File **PP-1996-044**

Name: Valley Meadows East – East of 25 ½ Road – North of Grand Valley Canal

REVIEW COMMENTS

FILE #PP-96-44

FILE: C:\HAASE\HAASE.DWG
 VALLEY MEADOWS EAST
 SUBDIVISION
 PRELIMINARY DRAINAGE MAP

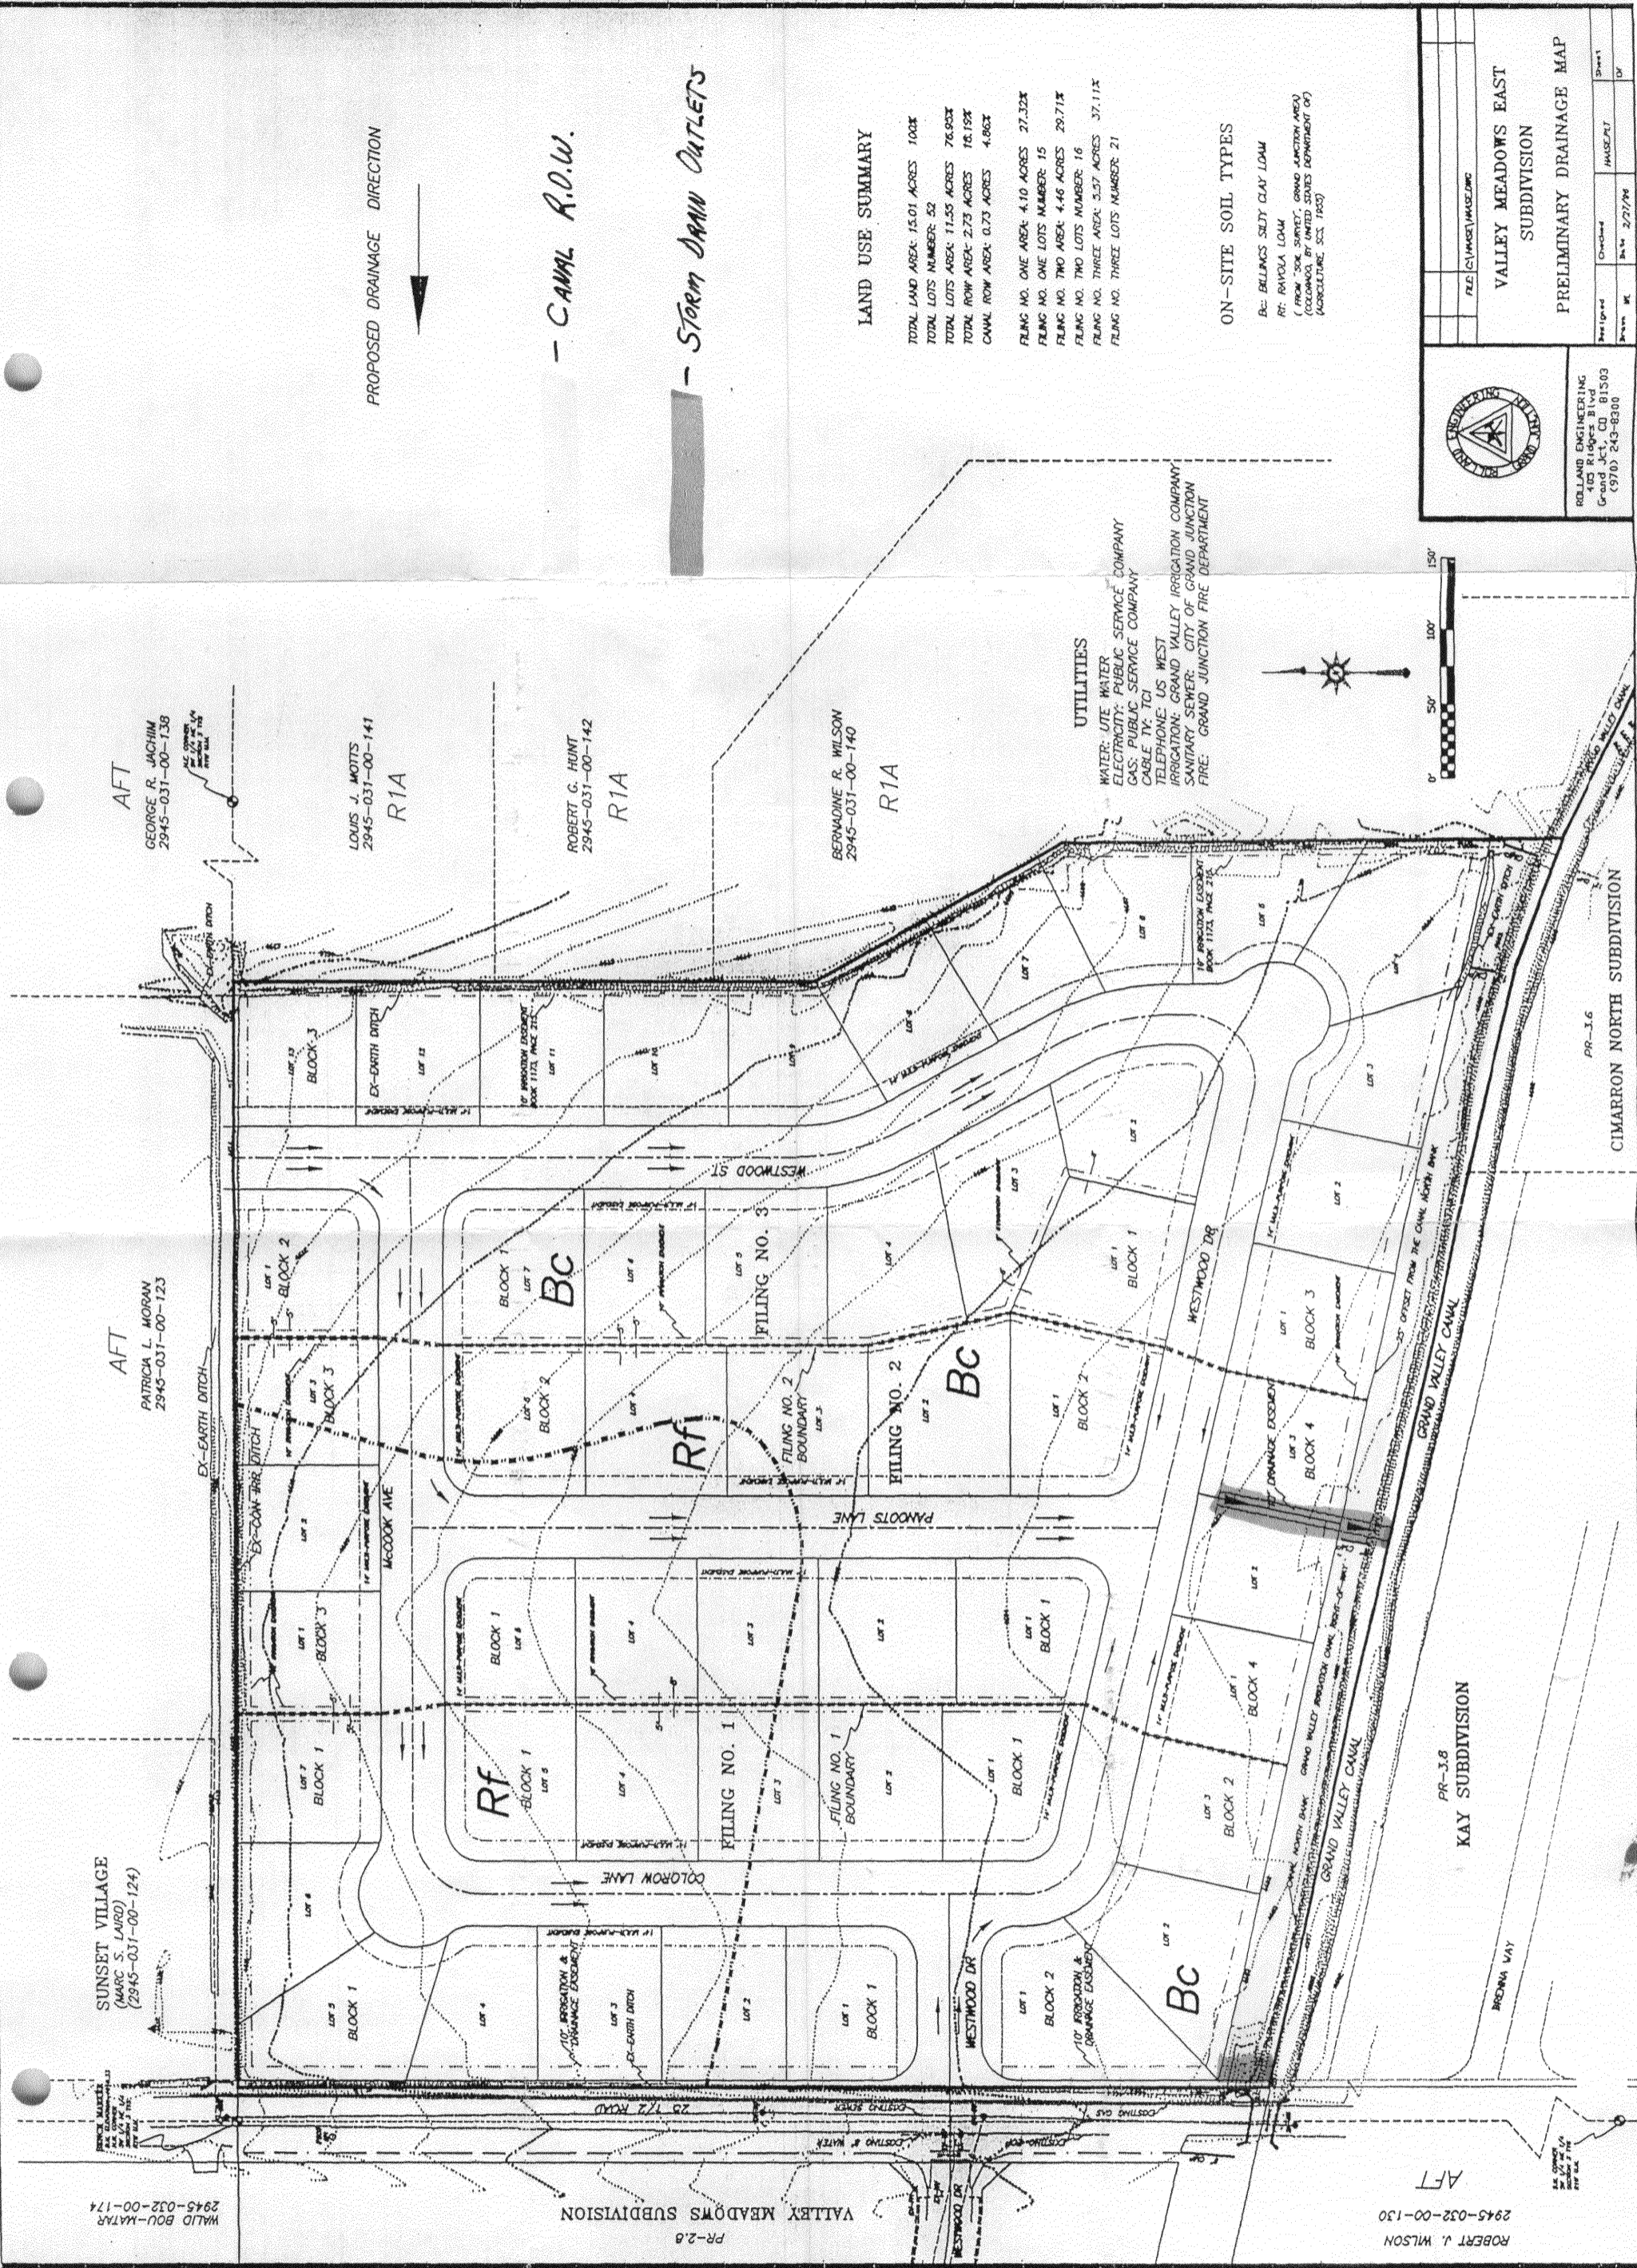
Because of the site constraints previously detailed, GWHC, Inc. requests that Grand Valley Irrigation Company allow the Valley Meadows East Subdivision to discharge stormwater runoff directly into the Grand Valley Canal without runoff detention. The tailwater ditch running along the western boundary of the property presently drains into the Grand Valley Canal at the southwest corner of the property. GWHC, Inc. wishes to continue draining into the canal at approximately the same location plus they wish to add an additional location centralized at the approximate middle of the southern boundary of the property. Easements will be platted for these two stormwater discharge locations. (See attached plan for locations).

GWHC, Inc. also proposes to create a Grand Valley Canal Right-of-Way along the entire southern boundary of the property for a width of approximately 25 feet. This area will be platted on the VME plat recorded at the County. (See attached plan).
